CBR-020

## RE: RESPONSE TO NDEQ EXCURSION MONITORING ISSUES

This letter report provides a response to Nebraska Department of Environmental Quality concerns regarding excursion monitoring at the Crow Butte Resources (CBR) uranium ISR facility.

**Figure 1. Water Balance in WH45/47 and Chloride Concentration in CM9-3  
October 2007 Through June 2008**

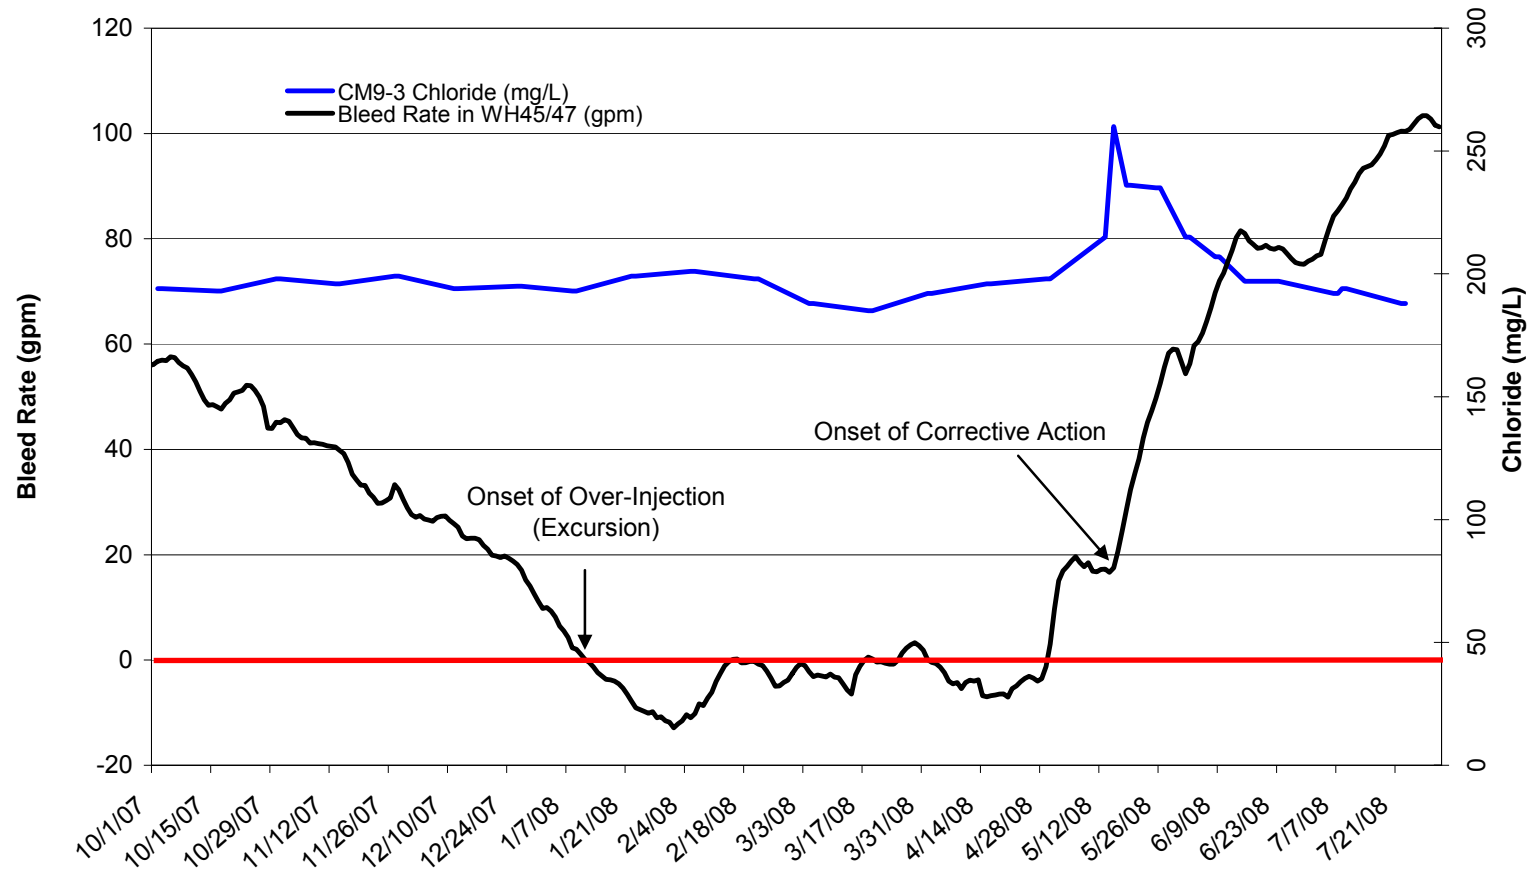
***Issue 1 - When Upper Control Limits (UCL's) are exceeded in a monitoring well, how far beyond the monitoring well do the constituents travel before the corrective action captures them?***

In the case of the May 2008 excursion in MU9, water balance data collected from Well Houses 45 and 47 (WH45/47) indicates that a local over-injection of mining solutions began in the first week of January 2008 and continued sporadically thorough the end of April 2008 (Figure 1). The average rate of over-injection in WH45/47 during this period was approximately 12 gallons per minute (gpm). The onset of the excursion was reflected as a rise in water level in the adjacent monitoring well ring during this time, including excursion monitoring wells CM9-3 and CM9-5 (Figures 2 through 10).

In this calculation, it is assumed a starting date for the excursion of January 1, 2008 corresponds to the onset of a local over-injection in WH45/47. For CM9-3, an excursion arrival date of May 15, 2008 is assumed based on the first noticeable increase in chloride, alkalinity and conductivity at this location (Figure 1). The resulting time of travel for conservative chemical parameters is 135 days. Given a distance of 270 feet from the mine patterns to monitoring well CM9-3, the groundwater velocity and speed of conservative chemical movement during the excursion is estimated to be 2.0 ft/day. A similar analysis for well CM9-5 using a distance of 250 feet from the mine patterns to the monitoring well yields a groundwater velocity of 1.85 ft/day. The resulting groundwater velocities calculated for CM9-3 and CM9-5 are very similar.

In response to the May 2008 excursion event, CBR began excursion corrective action by curtailing injection and increasing the extraction rate from perimeter production mining wells in WH45/47. Excursion corrective action was initiated immediately on May 15, 2008 as shown in Figure 1.

**Figure 11. Effects of  $K_d$  Values on Constituent Transport**

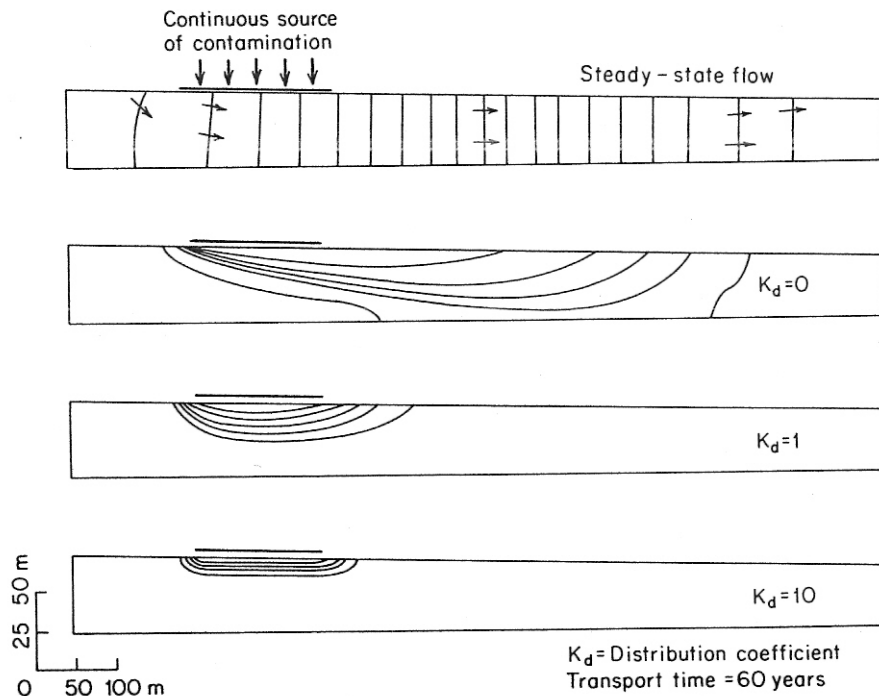
**Issue 2: *Could production fluids from the excursion detected in Mine Unit 9 in May 2008 and June 2009 increase uranium concentrations?***

A high  $K_d$  ( $> 10$  ml/g) indicates that a constituent is strongly retained by the aquifer solids and will travel much more slowly than the average groundwater velocity. Even a constituent with a relatively small  $K_d$  (e.g., equal to 1 ml/g) will be transported through groundwater much more slowly than a constituent that is not retained by the solid phases ( $K_d$  equal to 0 ml/g), as illustrated by Figure 11.
